**ADDENDUM NO. 1**  
**TO**  
**CONTRACT DOCUMENTS AND SPECIFICATIONS**  
**FOR IMPROVEMENTS FOR**  
**APRON PAVEMENT REHABILITATION – PHASE 2**  
**FOR THE**  
**DALTON MUNICIPAL AIRPORT**  
**DALTON, GEORGIA**

**Croy Engineering, LLC Project 2106.005**

Date Addendum Issued:  
November 29, 2022

C-200

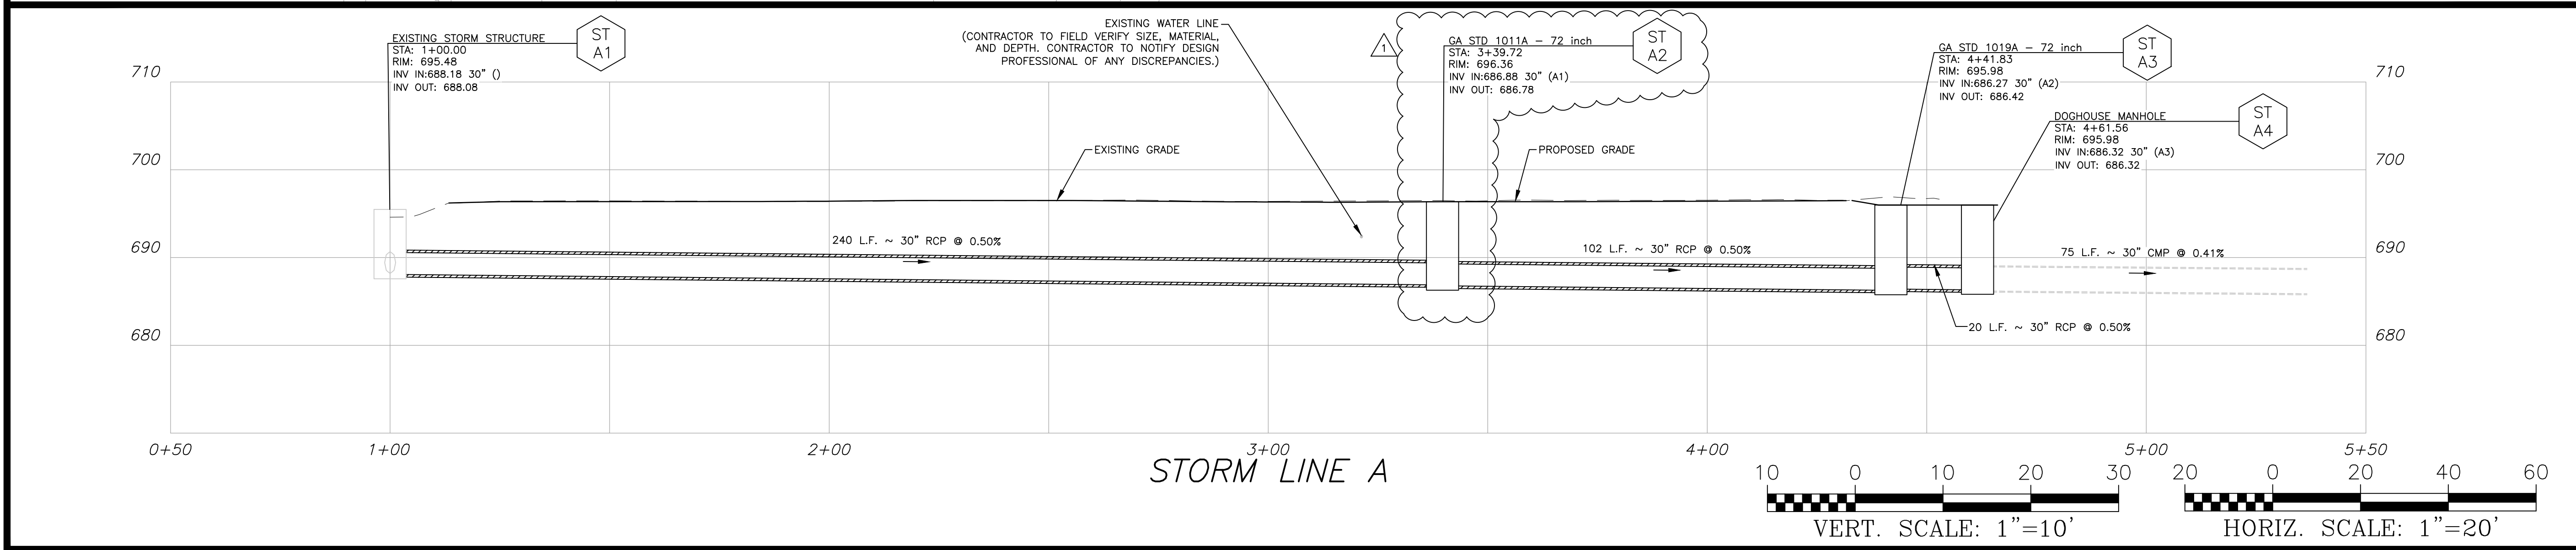
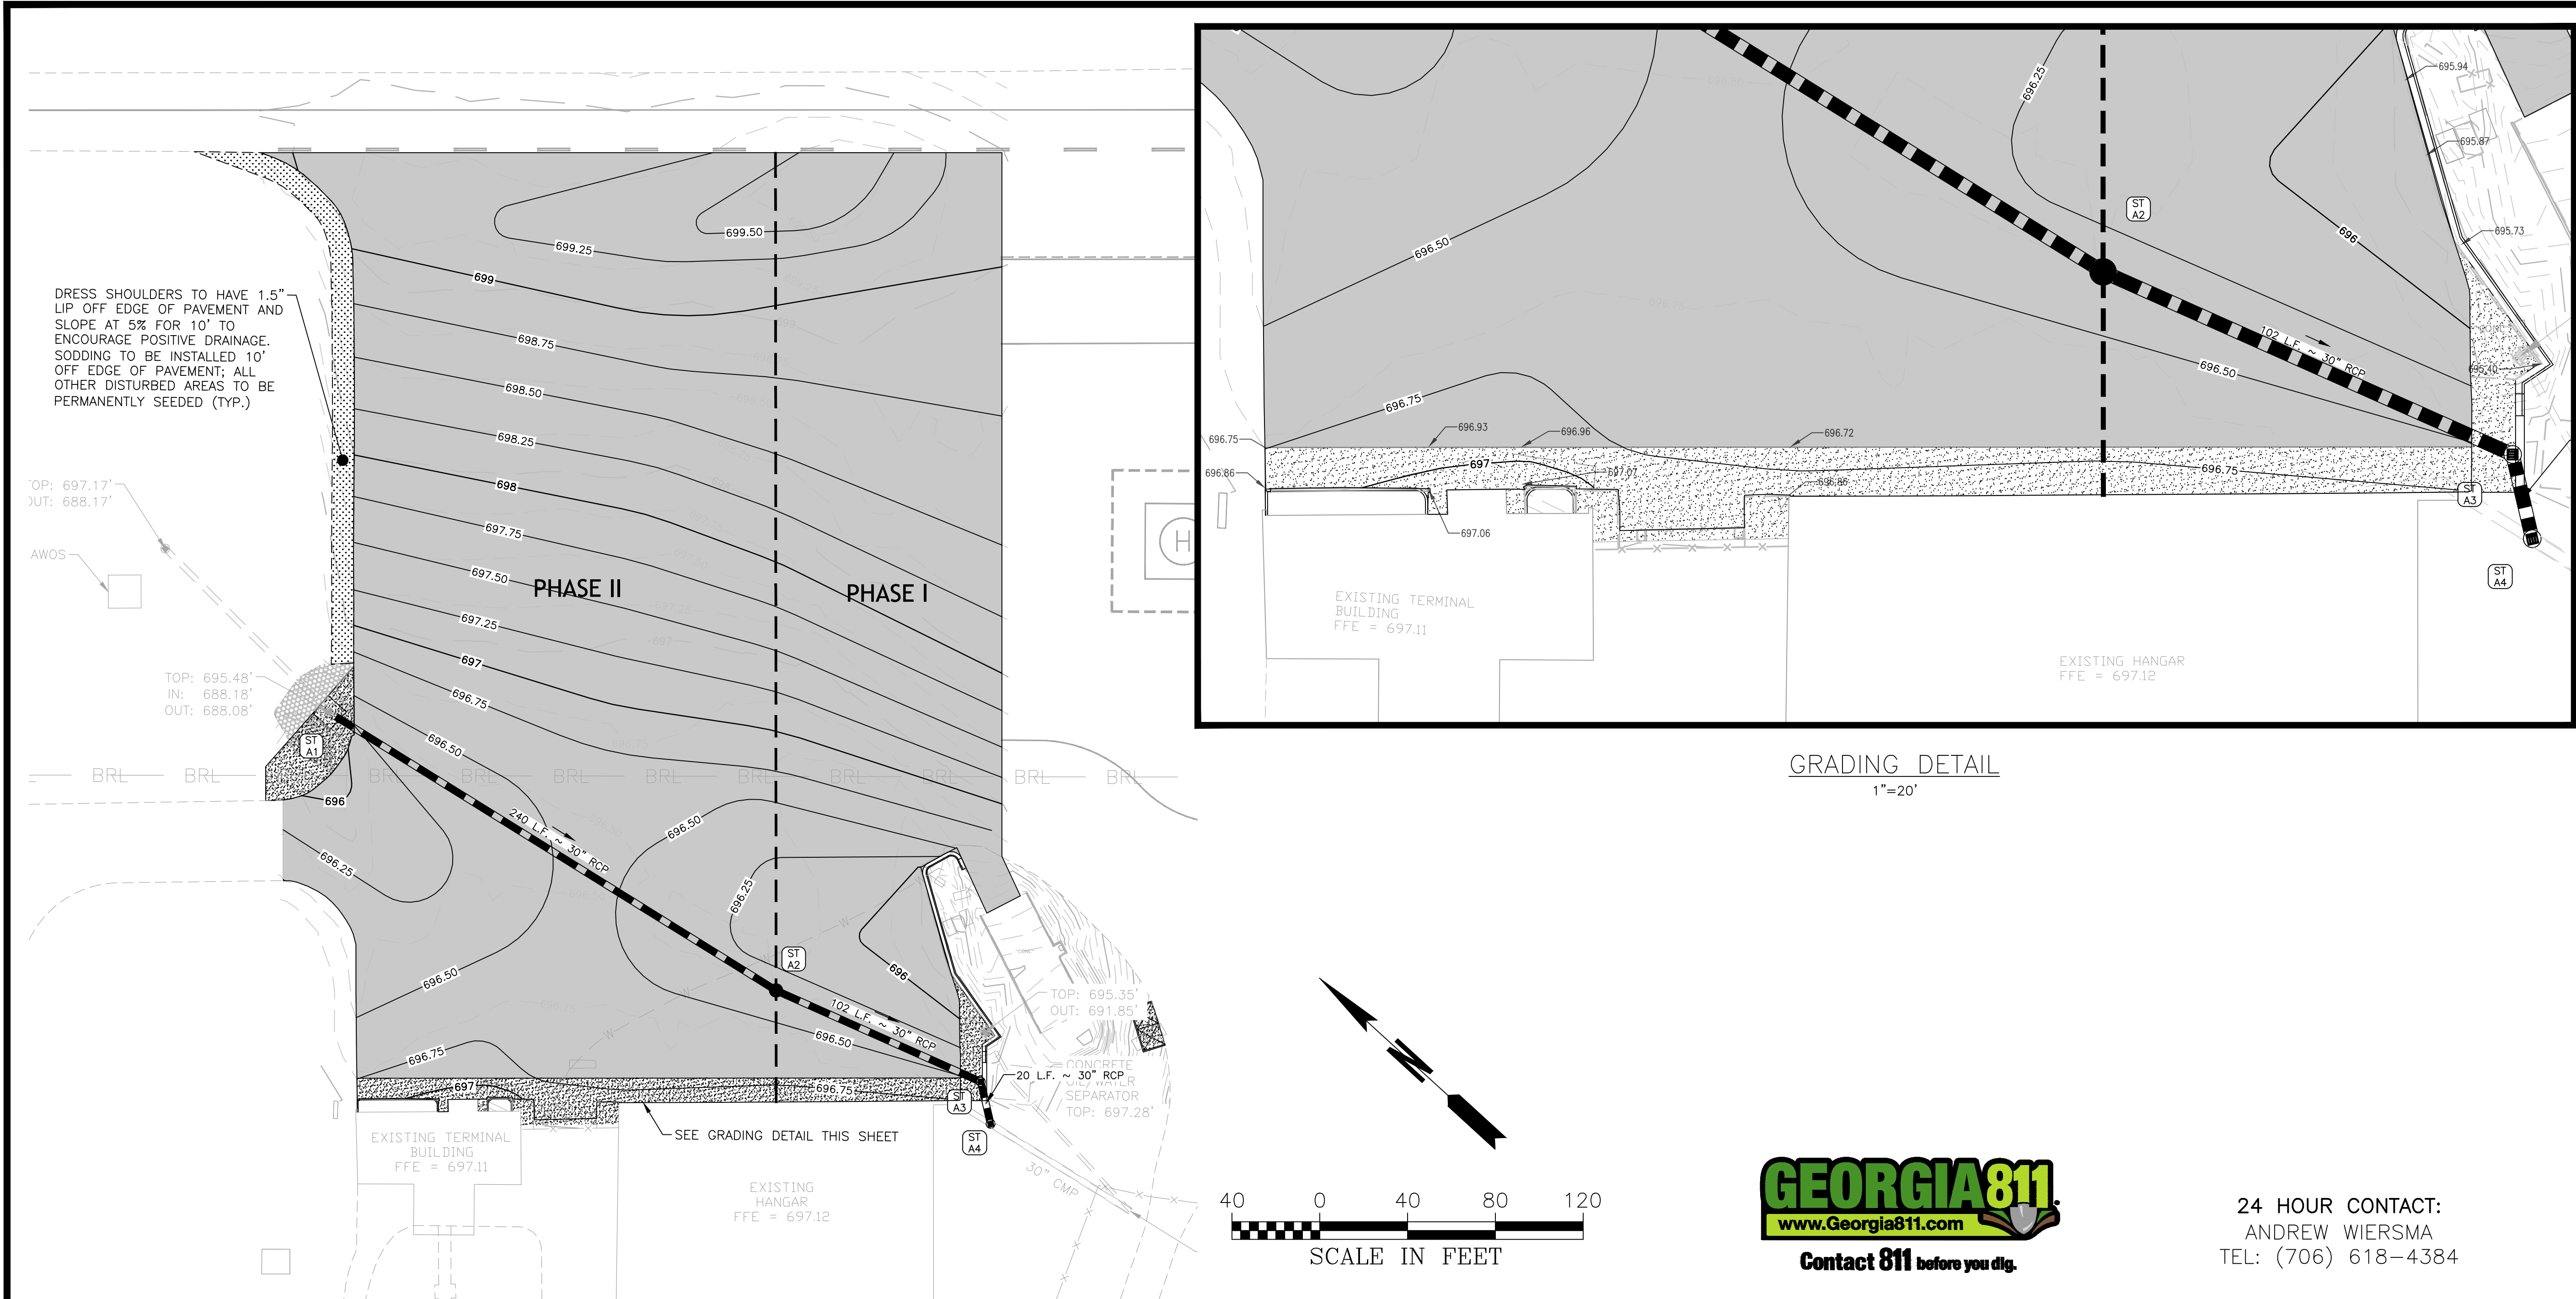
- *There is a Geotech report, and it is attached for reference.*
  6. Can manhole A2 be moved to the dividing line between phase 1 and phase 2 or will an additional manhole need to be added?

NO.	REVISION	REFERENCE	DATE
1	MOVED JB TO PHASE LINE		11-29-22

- *Manhole A2 can be moved to the phase line. However, adjustments to the elevations may be required to maintain grade.*
  7. When the Induction Loop/Sensor for the gate is removed, does removal of that loop require temporary security?

REINFORCED CONCRETE PAVING DETAIL  
NOT TO SCALE

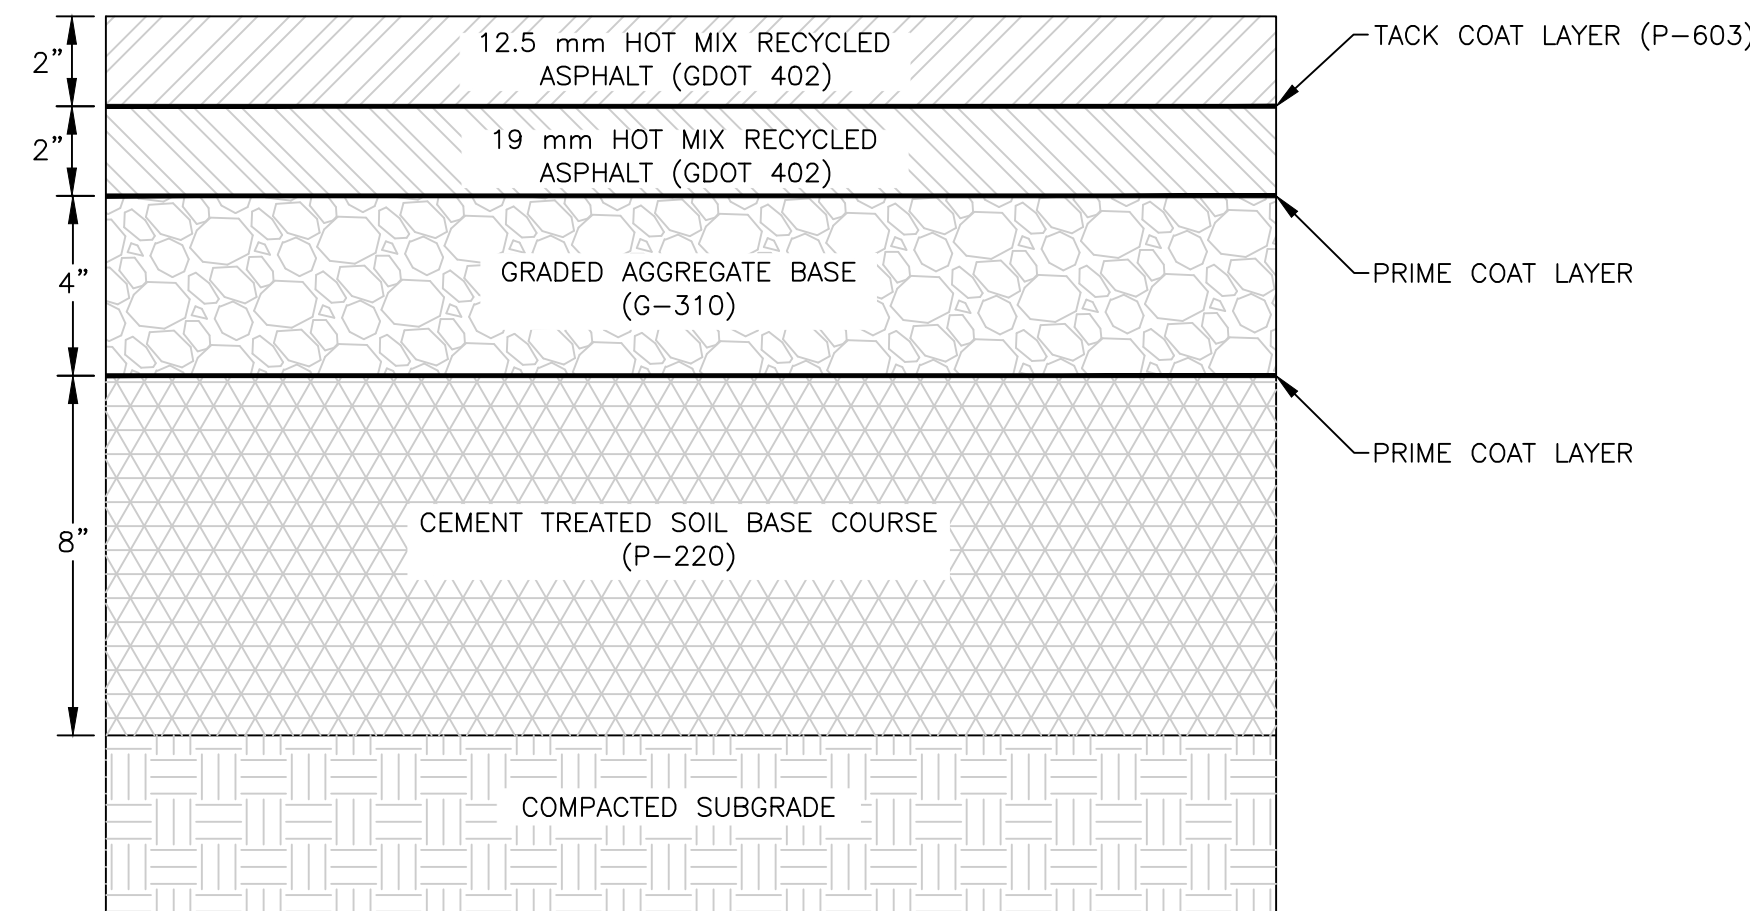
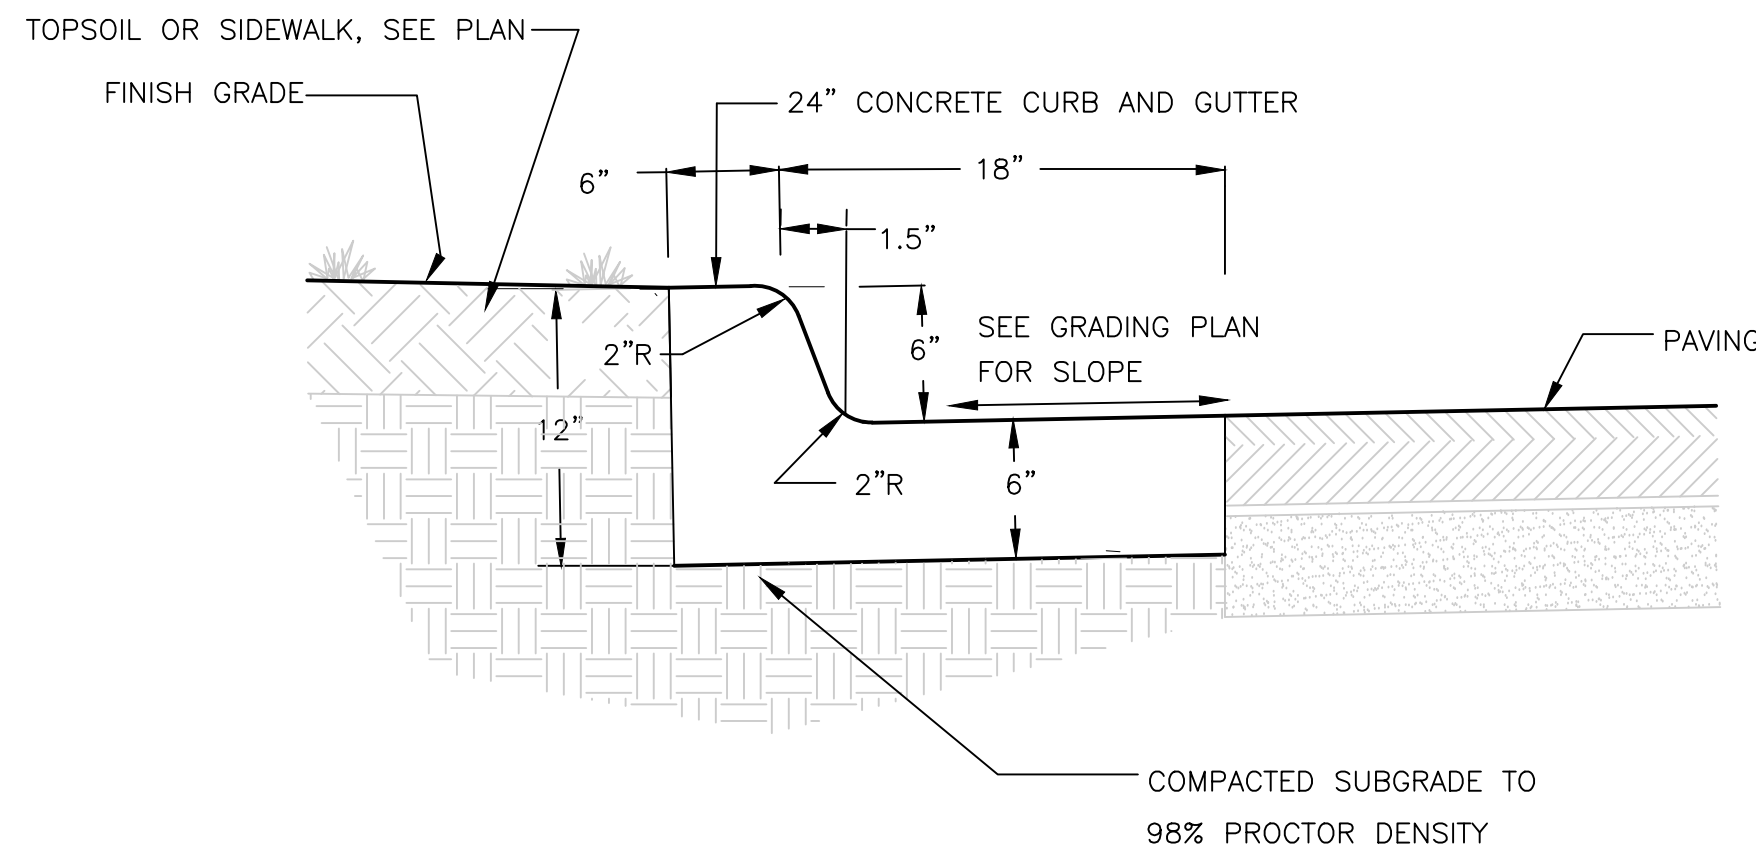
- *3,000 psi Class A concrete shall be used*
  10. On plan sheet C-300, Note #1 for Reinforced Concrete Paving Detail states that the concrete will be 4,000 psi. The Summary of Quantities block on plan sheet G-001 states that the 6" Reinforced Concrete Paving will be as per Ga DOT Specification 430. The required concrete in this specification is Class 1 which is 3,000 psi. Please clarify which is correct.

NO.	REVISION REFERENCE	DATE
1	ALL CONCRETE TO BE 3000 PSI	11-29-22

- *3,000 psi Class A concrete shall be used*
  11. Note #13 on plan sheet G-001 states that all site concrete will be 4,000 psi at 28 days. The Summary of Quantities block on plan sheet G-001 states that the 24" Concrete Curb & Gutter & the 6" Concrete Header Curb items will be as per Ga DOT Specification 430. The required concrete in this specification is Class B which is 2,200 psi. Please clarify which is correct.
